ADDENDUM NO. 2
TO
CONTRACT DOCUMENTS
For The
CITY OF DELRAY BEACH
**ARCHITECTURAL CONSULTING SERVICES:
DELRAY BEACH RAILWAY STATION
PROJECT NO. 16-080
BID NO. 2016-081C**

- **Enclosed for your review and information are the Historic Train Depot plans for the Delray Beach Railway Station.**
- **Bid Opening date has been extended to Tuesday, April 26, 2016 at 2:00 PM.**

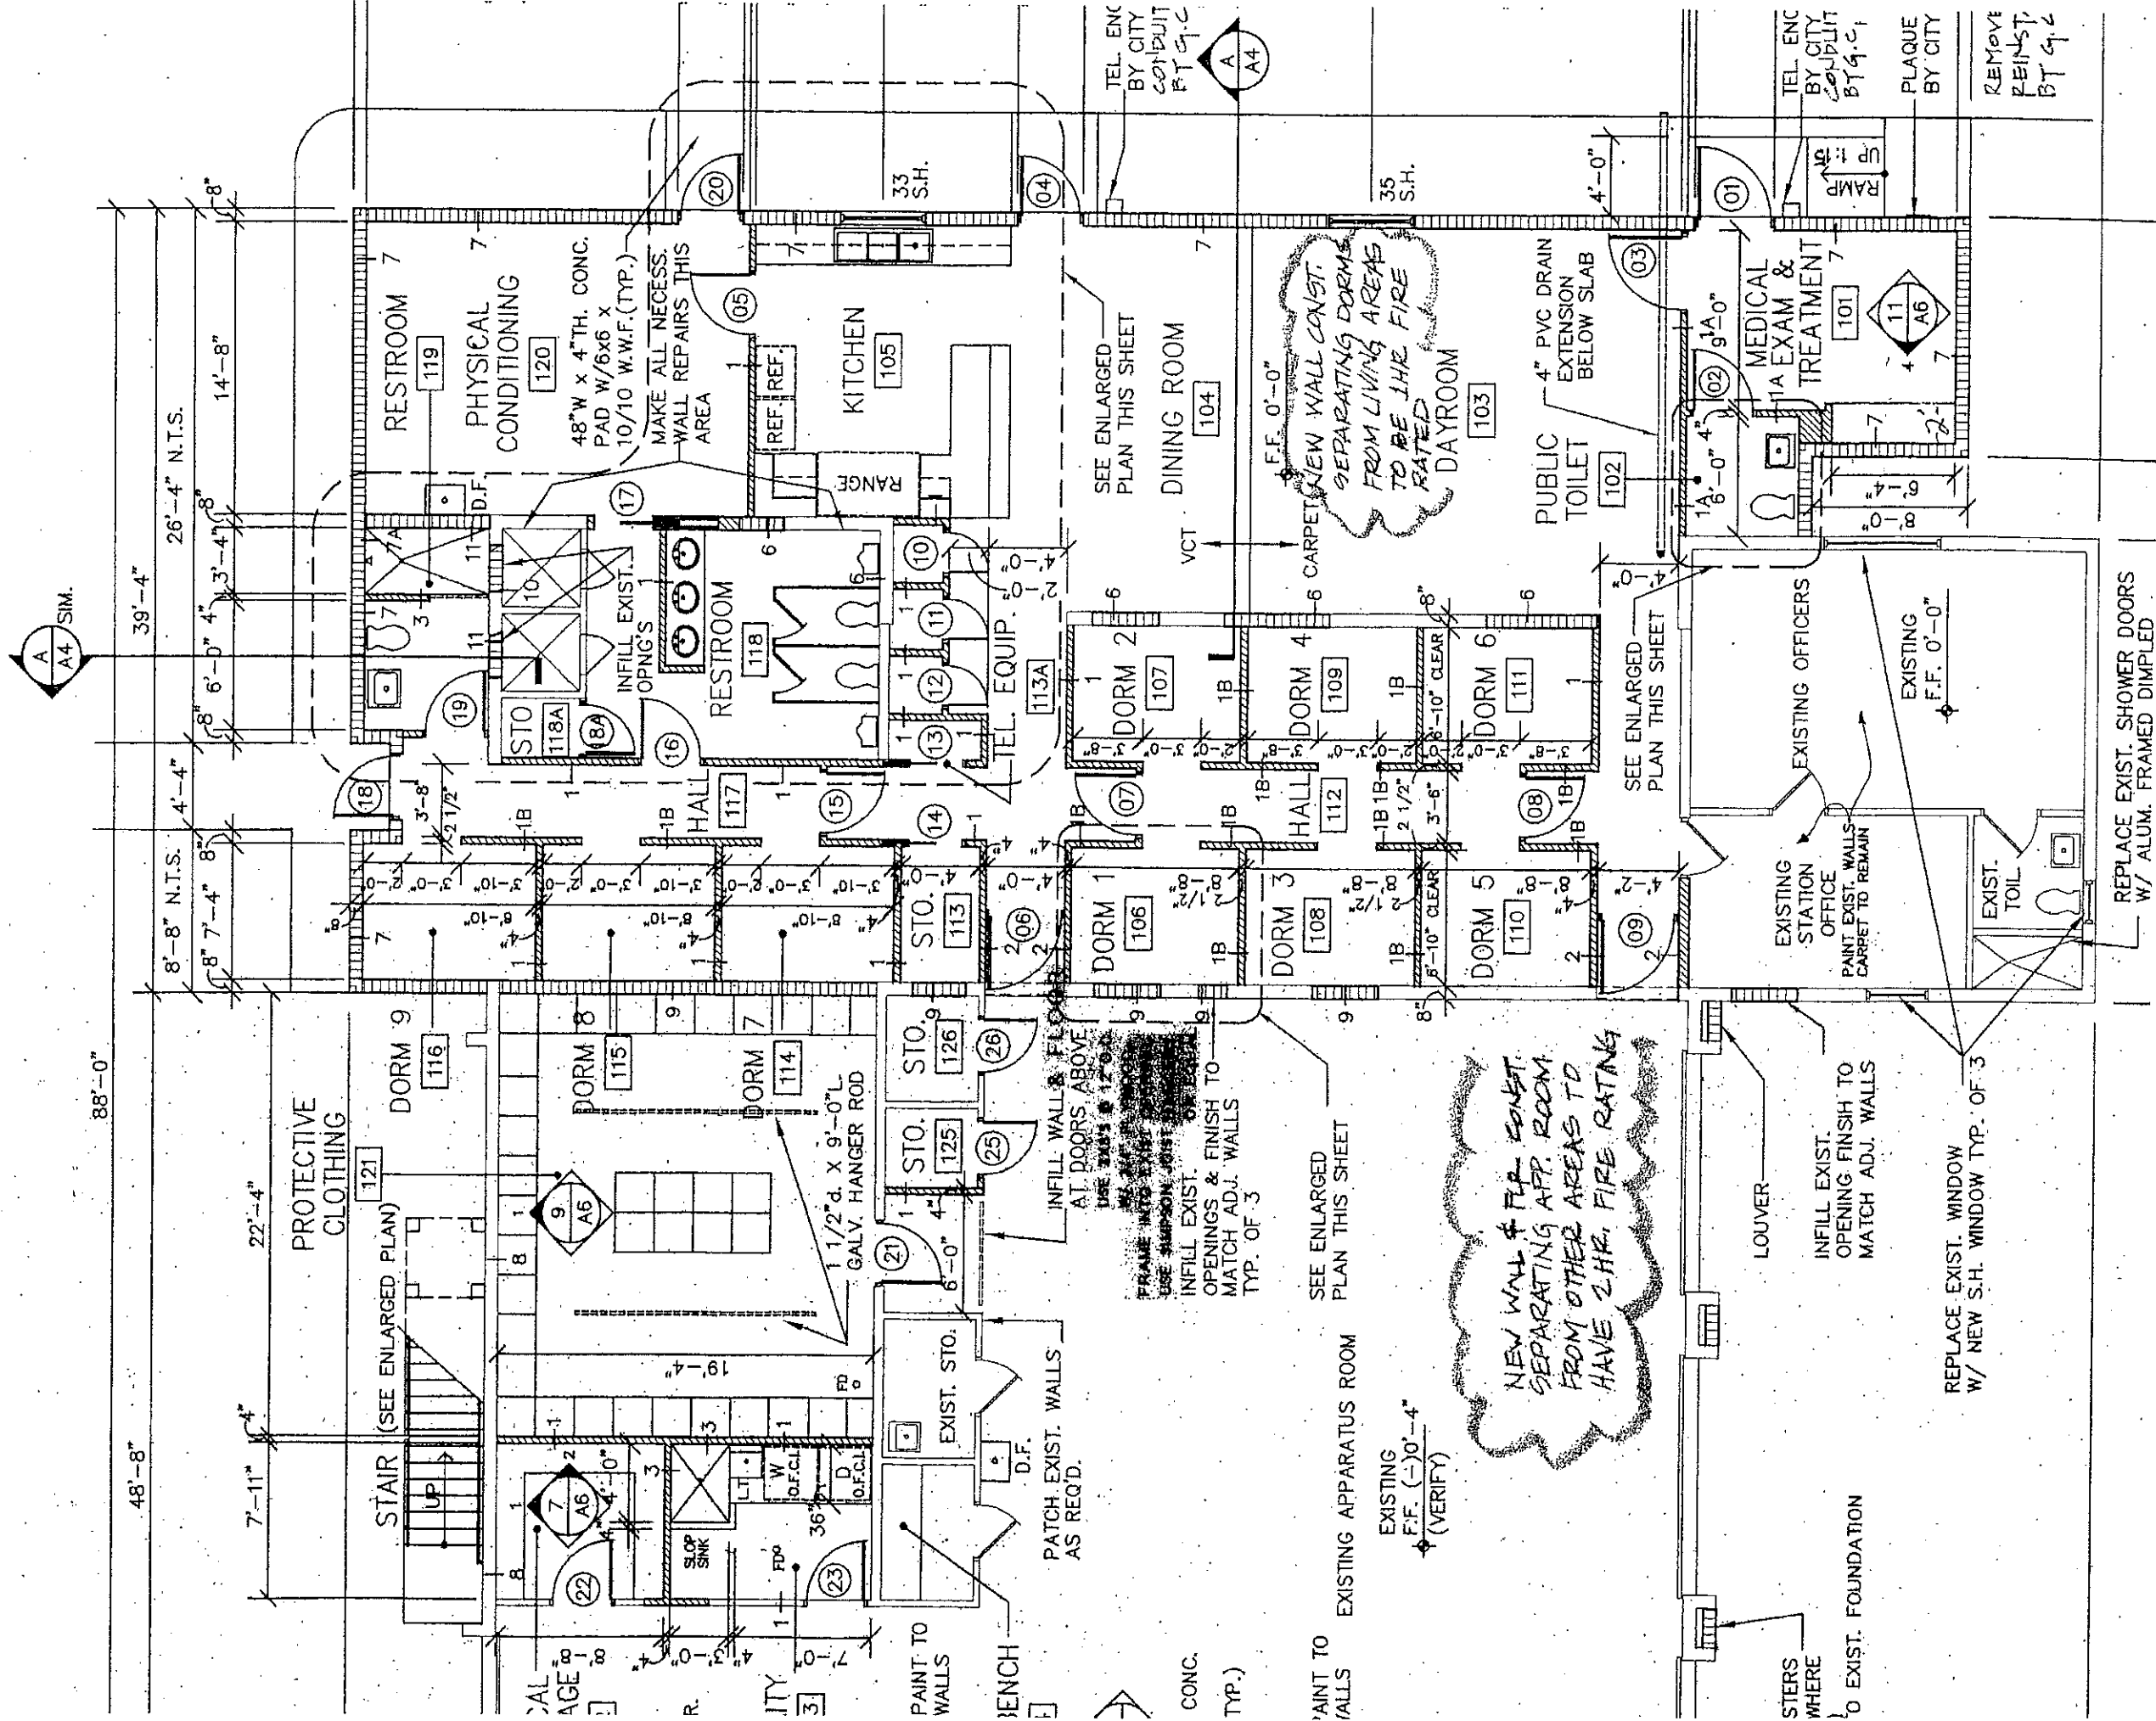
A103.2.4 Structural And Fire Resistance Integrity. Plans for all buildings shall indicate how required structural and fire resistive integrity will be maintained where a penetration of a required fire resistant wall, floor or partition will be made for electrical, mechanical, plumbing and communication conduits, pipes and systems and also indicate in sufficient detail how the fire integrity will be maintained where required fire resistant floors intersect the exterior walls.

8-2-88 Don (3) from Conference Room shall be site inspected for
as sheet 1114.1.1 5809
Include inspection results table
Don (4) shall bring out the table
Include site inspection of Don @ 60" x 60" x 51 x 72"
for substation terminal.
Obtain CAB approval for extension charges

Partial Floor Plan W/ Alterations

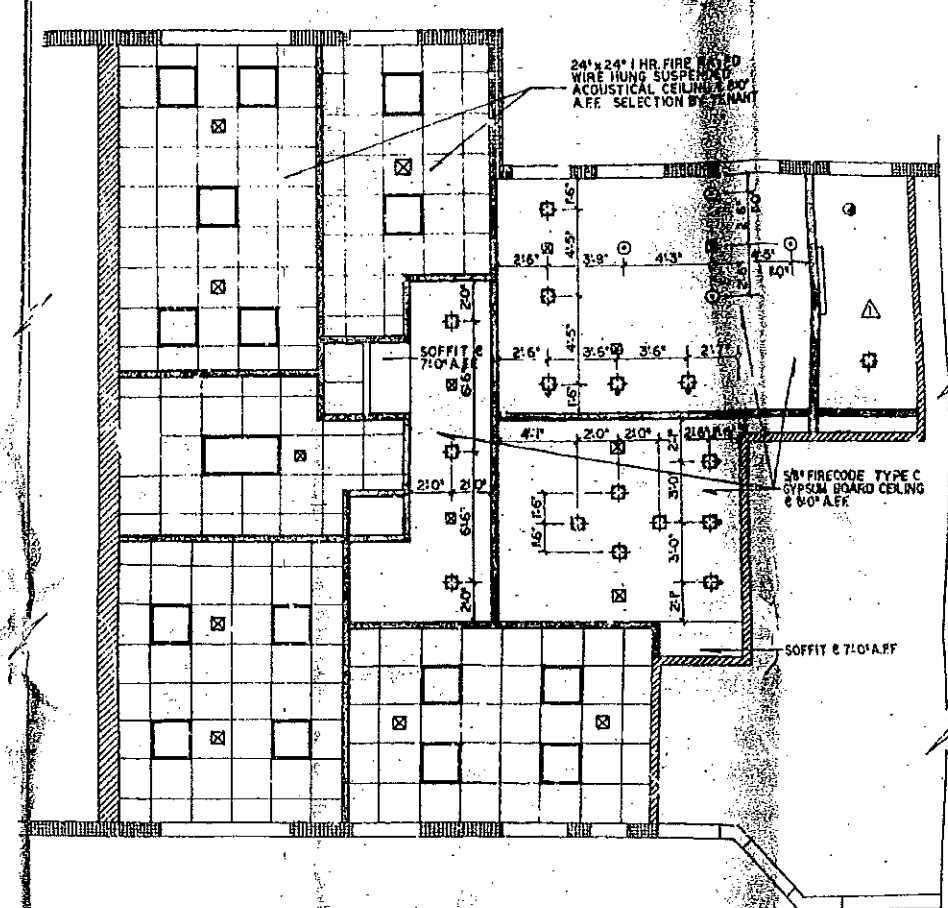
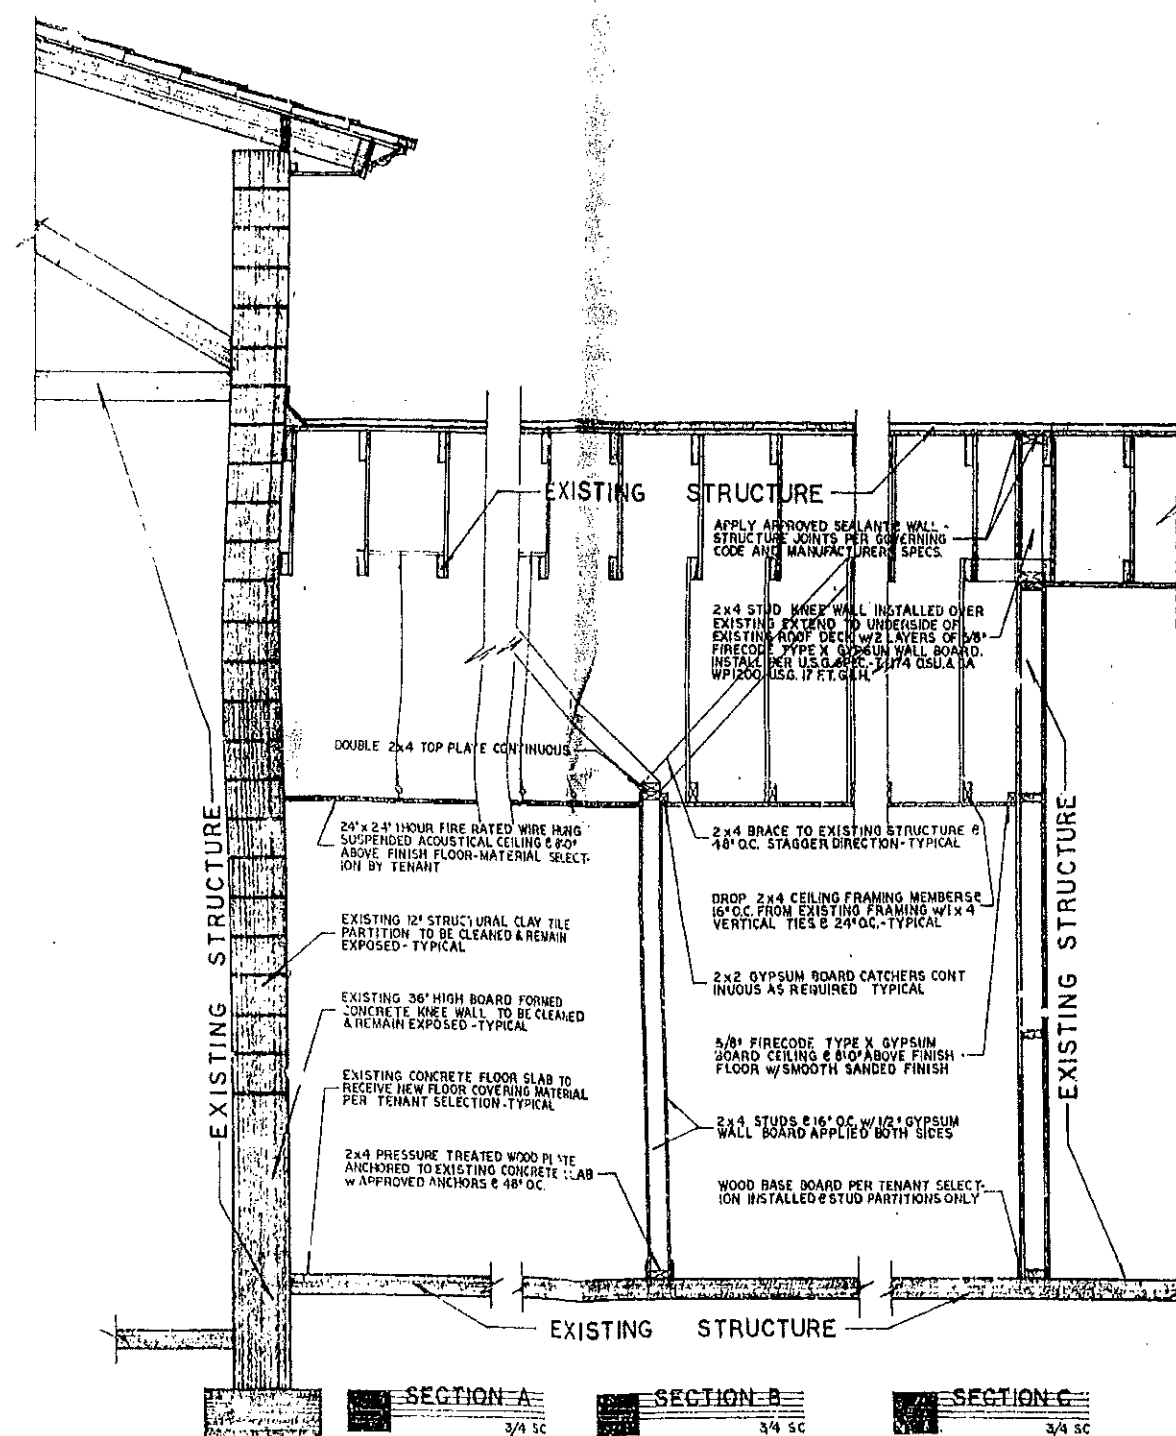
6-3-88 REVISE LAV. ST. LIN. DOORS & SCHEDULE
